Zoning Staff Report

Case Number: ZC-22-019

Zoning Map Amendment & Site Plan

VILLAGE AT GOLDEN TRIANGLE
 29.7 ACRES OUT OF THE
 WILLIAM MCCOWAN SURVEY, ABSTRACT NO. 999
 CITY OF FORT WORTH, TARRANT COUNTY, TEXAS

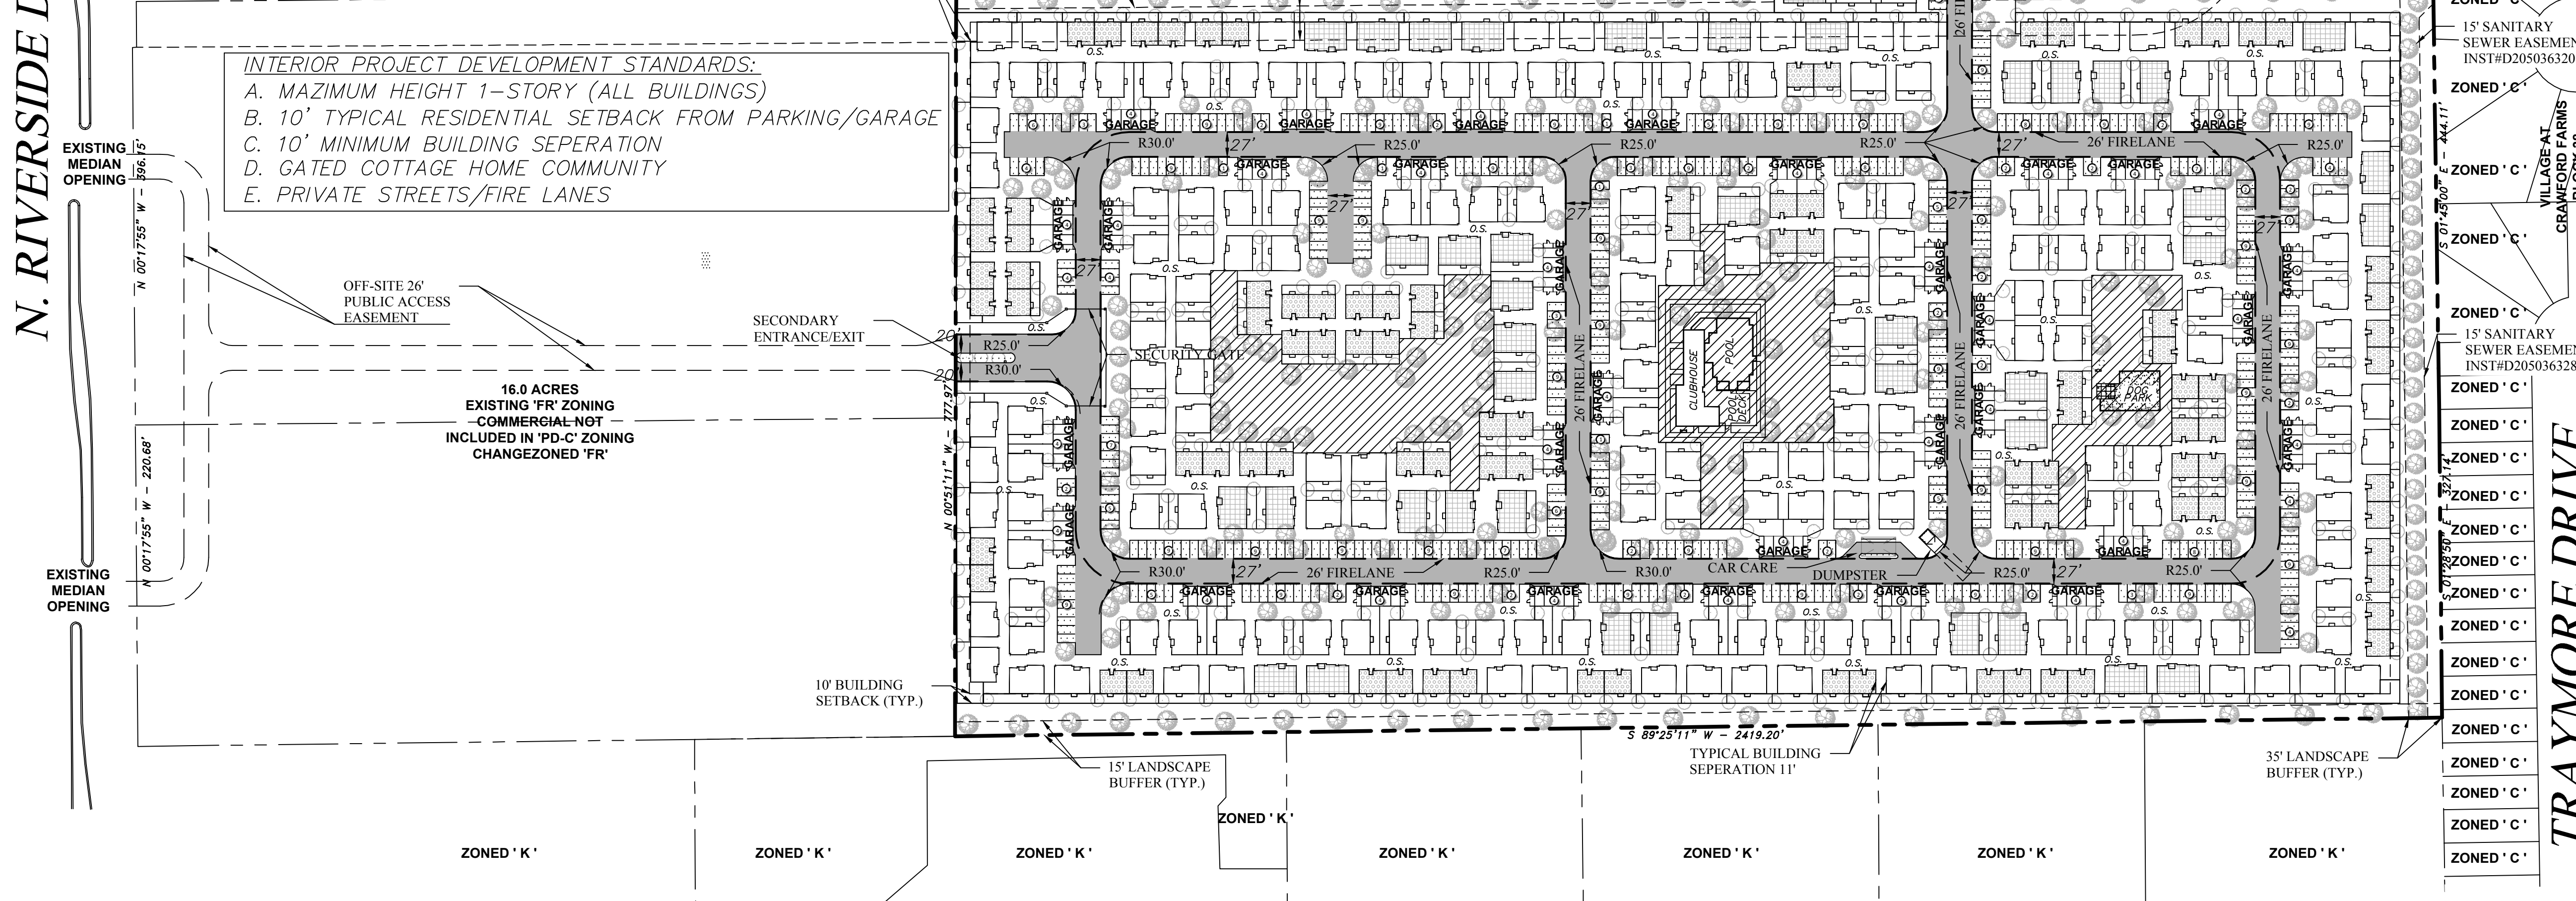
- ~~Parking provided exceeds minimum required, however clubhouse parking is not accounted for in the requirements. 2,400 square foot clubhouse would increase the parking requirements by +10, from 595 spaces to 605 spaces, based on the current unit counts.~~

- ~~Appears to comply with 36' max height, but confirm that heights shown in chart for 3 bedroom units are correct (21' height but 1 story?)~~
- ~~1 parking space (9'x18') per bedroom, plus 1 parking space per 250 per club or office space. Tire stops are not required if the parking lot has a curb, but if you are installing any tire stops, please depict those on the site plan & ensure 18' measurement is measured from tire stop back. Add a note to the effect of confirming all parking spaces will meet minimum dimensions found in COFW Zoning Ordinance Section 6.202.~~

- ~~Correct signature line to "Director of Development Services"~~
- ~~Provide comparison chart on Site Plan. Utilize existing "C" table with all line items, adding a comparison column showing PD standards and notation showing compliance ("Complies") or waiver ("Does not comply" & list variance).~~

- ~~Note 10 Strike note. Staff is not supportive of straying from the definition of Open Space contained in 4.711.d.7 of the COFW Zoning Ordinance. If the Open Space falls below 45%, simply request a waiver through the PD for the lower amount.~~

- ~~Note 11 Remove private yards from Open Space calculations. Staff is not supportive of counting private yards in the calculations for Open Space. If the Open Space falls below 45%, simply request a waiver through the PD for the lower amount. The amount shown currently of 52.1% less private yards at 8.7% would give you 44.2%, which is less than a percentage point from meeting the minimum of 45%. Numbers may shift below 44.2% based on comment above regarding note 10.~~

- ~~Provide separate exhibit (upload to Accela) showing Open Space diagram with green shading as well as calculations. Refer to COFW Zoning Ordinance Section 4.710.d.7.g for what areas count towards calculation of Open Space.~~

- ~~Remove Monument Sign from Site Plan (note on plan showing compliance should be sufficient)~~
- ~~Amend height in comparison table to capture clubhouse @ 23' 2"~~

- ~~Double check & possibly correct south & east setbacks~~
- ~~Upload Revisions to Accela (can email me a copy as well just to be sure)~~

1. Two points of ingress/egress required. (two points are not shown as compliant)

Minimum turn radius for fire lanes is a minimum of 25' inside and 51' outside. (inside radius shown as compliant)

Where divided by a median, fire lanes must be a minimum of 20' on either side of the median.

Each building will have its own address. Each building address shall be clearly visible from the corresponding street or marked fire lane. ("stacked" buildings will be difficult to locate)

Units farther than 25' from the curb line, the numbers shall not be less than 6" in height.

Vehicle gates are required to be a minimum of 20' wide when fully opened and equipped with Knox Locks. Access Control Permits through the Fire Department are required.

Additional hydrants will be required.
